MFN 10-312

Docket No. 52-010

**Subject: Reply to Notice of Violation, NRC Inspection Report 05200010/2010-201**

**Enclosure 1**  
**Reply to NRC Notice of Violation**  
**Docket Number 05200010**  
**Inspection Report No. 05200010/2010-201**

Case 5 as example of new model plots showing boundary conditions

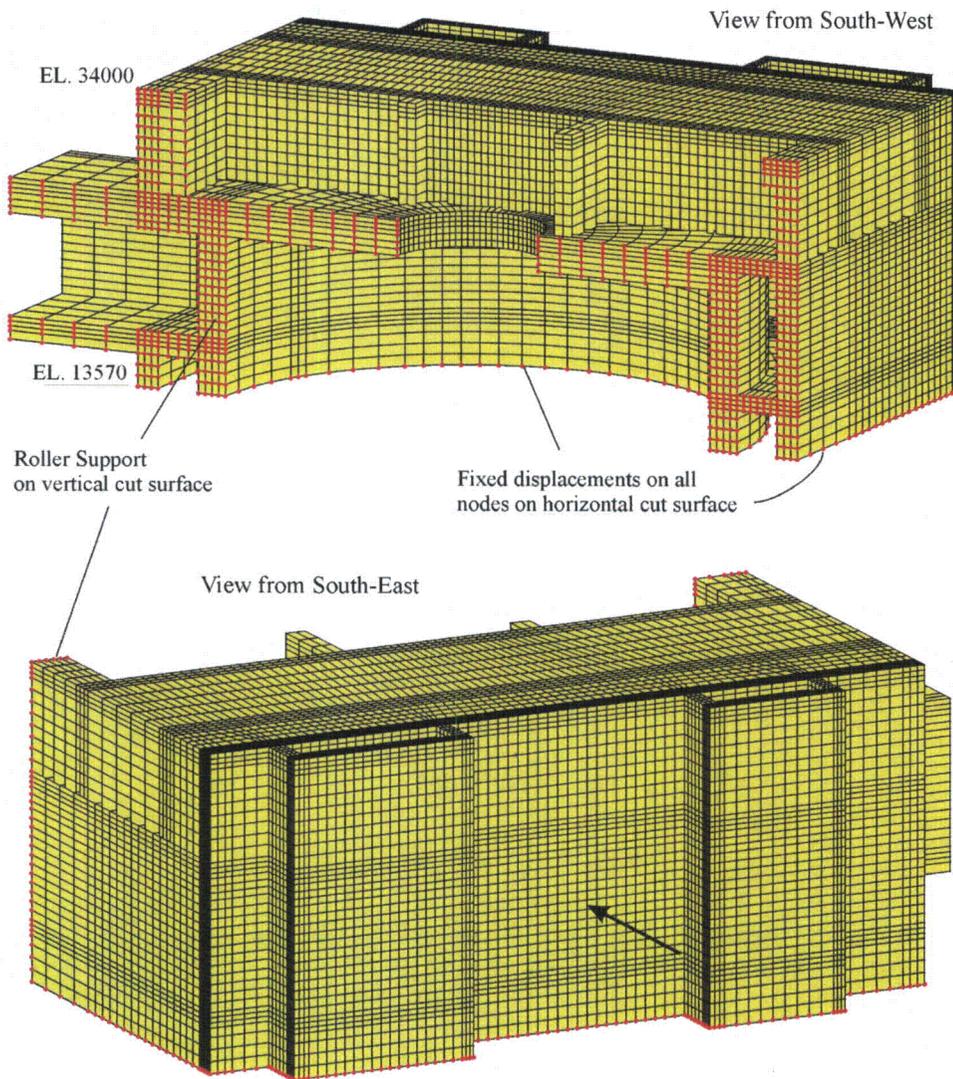
Contrary to the above, as of September 01, 2010, GEH failed to use realistic analyses in certain aspects of its AIA. Specifically, in its AIA, the applicant failed to adequately consider finite element analyses boundary conditions, initial conditions, and the time duration.

The GEH assessment did not adequately document GEH conclusions and assumptions regarding finite element analyses boundary conditions, initial conditions, and the time duration in the analyses, as well as the physical extent of each model.

The corrective action is to provide better documentation in the analysis report, ANA-QA-0207, "Evaluation of Aircraft Impact on ESBWR Plant Design". A new section, Overview of Finite Element Modeling, is being added to Chapter 2, Analysis Methods and Procedures, to better describe the modeling methods employed (see below), and new model plots illustrating the boundary conditions used for each model are generated and put into the report (see example below).

#### Model Extent and Boundary Conditions

The structural analyses involve a large extent of loading on large structures. For computational reasons, the models are limited to regions of the structure in the general vicinity of the impact location. Some models have boundaries that represent cut sections through walls, floors, girders, and columns of the building. Displacement boundary conditions are enforced on these model boundaries with the intent to generally simulate the effect of that part of the structure that is not included in the model. For example, where a wall or horizontal girder is cut vertically for a model boundary, roller boundary conditions (the displacements normal to the surface of the cut) are applied to simulate that the wall continues beyond the cut, which provides support for the surface of the cut. The displacements transverse to the direction of the wall at the cut are not restrained so that the cut surface is free to move in the transverse direction. For the vertical cuts on walls along the back of the model, these roller supports also provide reactions for the applied loading. Generally the bottom surface of the model is fixed to represent embedment. These displacement boundary conditions are considered conservative because they force the impacted wall to carry more of

the load without the benefit of energy dissipation from overall movement and the inertia of the larger building.
